CITY OF AUSTIN – PLANNING AND DEVELOPMENT REVIEW DEPARTMENT
SITE PLAN APPLICATION – MASTER COMMENT REPORT

CASE NUMBER: **SP-2013-0069D**
REVISION #: **00** UPDATE: **U0**
CASE MANAGER: **Ron Czajkowski** PHONE #: **512-974-6307**

PROJECT NAME: **River Hills Sports Park**
LOCATION: **1200 RIVER HILLS RD**

SUBMITTAL DATE: **March 20, 2013**
REPORT DUE DATE: **April 17, 2013**
FINAL REPORT DATE: **April 15, 2013**

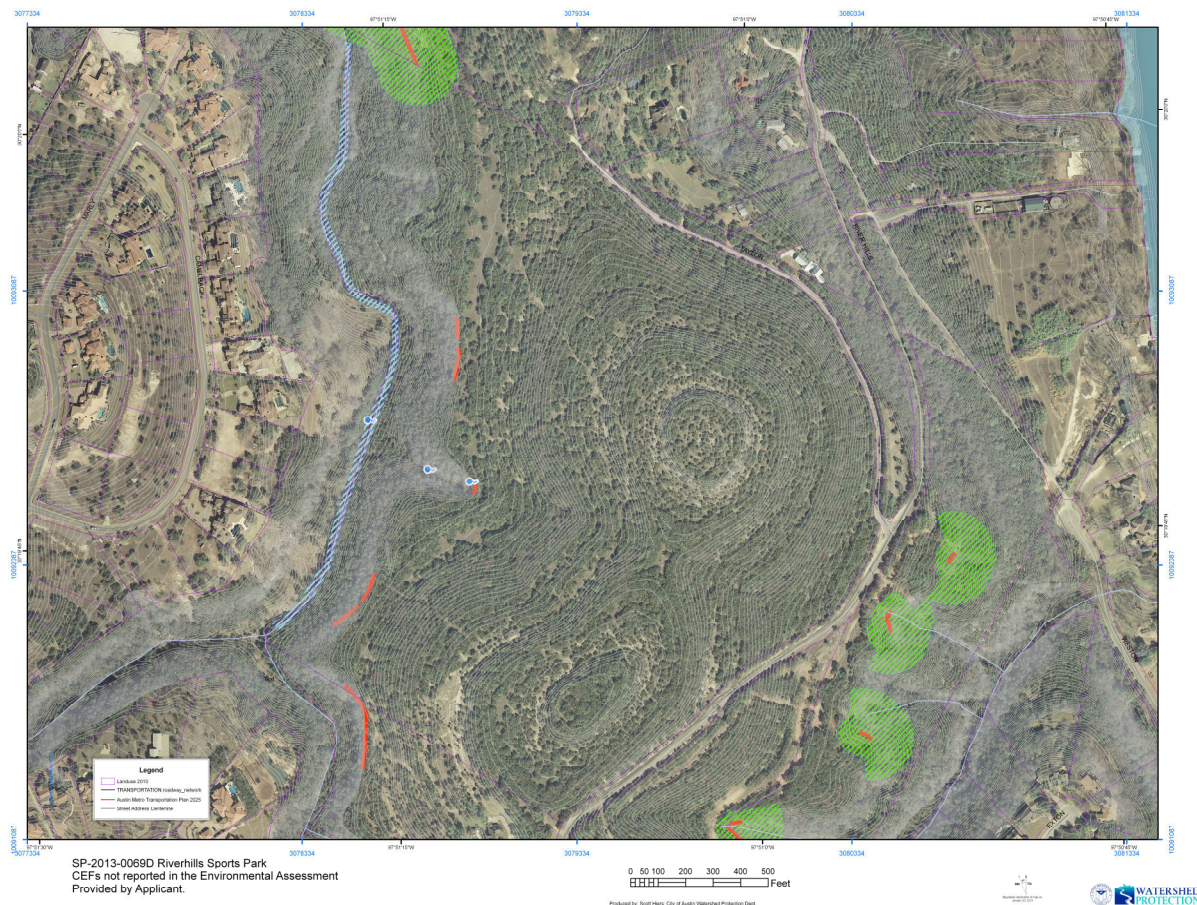
HG1- The Environmental Assessment provided is not accurate. At least 9 additional CEFs were identified by COA staff during our brief 2-hour site visits on April 11th, 2013 and more may be present (see map below). Please provide an Environmental Assessment that identifies all the CEFs on site.
